## Planning Staff Report to the Allentown City Planning Commission January 10, 2023

### Proposed Dental Office

**Project Title (Number):** ChildSmiles Dental Land Development (LMA-2022-00022)

**Project Location:** 1802 and 1814 Tilghman Street    **Type:** Major LD/**Prelim-Final** Plan

**Fig-3. Aerial project vicinity showing features of the site plan (existing and new buildings, access points, parking).**

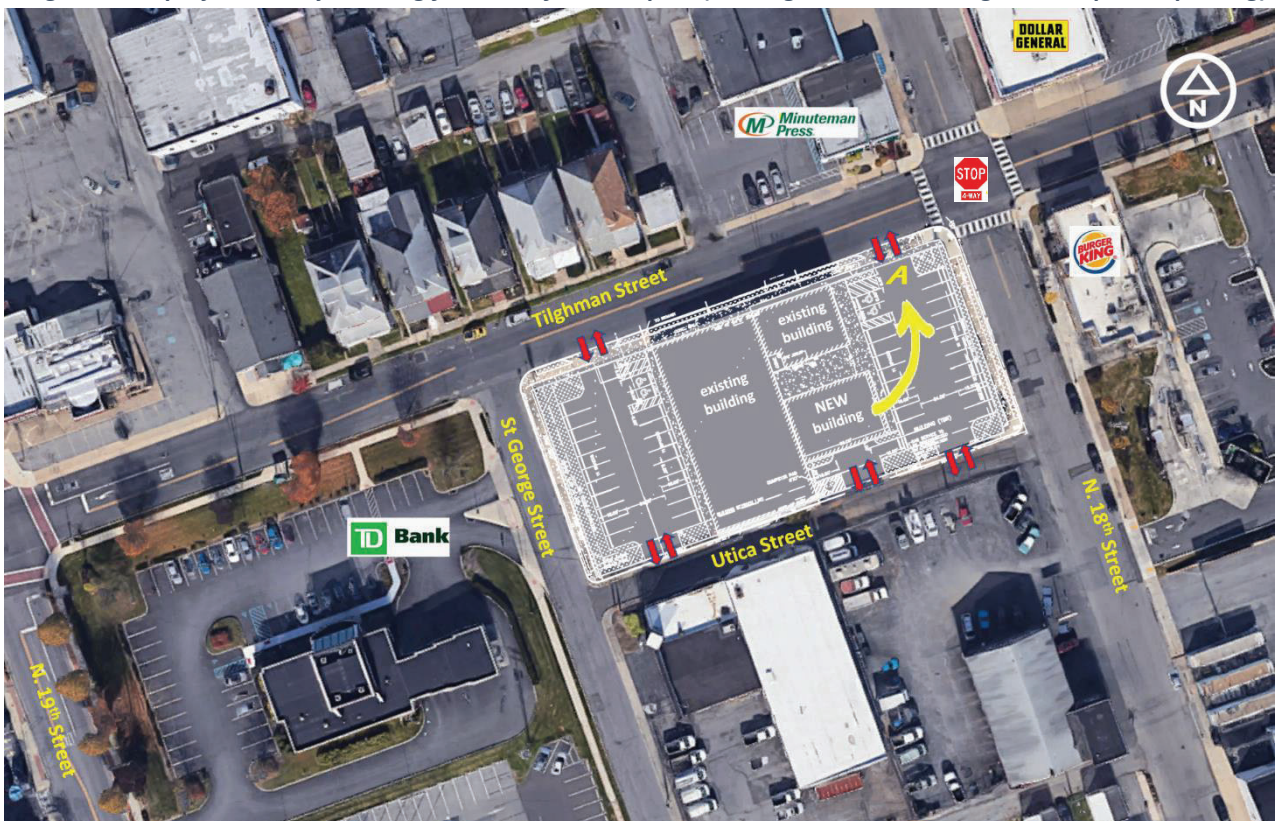
7. As regards **access** and **siting**, the plan is to install five (5) ingress-egress points: two on Tilghman Street and three on Utica Street (as denoted by the red arrows in Fig-3). And, to construct the new building in the interior of the lot, attached to the east side of the existing long building. *To achieve a safer pedestrian and vehicular flow and better street appeal, staff suggests the following changes:*

- *Afford the pedestrian a continuous and safe path to walk on without the need to watch and stop for vehicles entering and/or existing the development.*

- b. *Move the proposed building to location A to line up with the existing building line. This is expected to:*
    - *Result in a continuous building line of well-maintained facades rather than a parking lot, which makes for better street appeal.*

- *Hide the parking lot from the primary thoroughfare and instead showcase the new building, which is proper.*
8. While the lighting plan calls for the installation of at least 9 lighting fixtures on the site, the plan is not clear where these fixtures will be installed/located. *Staff believes this is important for the ACPC to see in order to appreciate the adequacy of on-site lighting as this relates to engendering a sense of safety and security for both patrons and pedestrians.*
    - a. *The ACPC may wish to request the applicant to resubmit its lighting plan, mindful of visibly showing the locations of the fixtures.*
  9. Finally, the applicant proposes to integrate the two parcels comprising the site. Staff deems this action as most ideal and *recommends approval of the lot consolidation.*
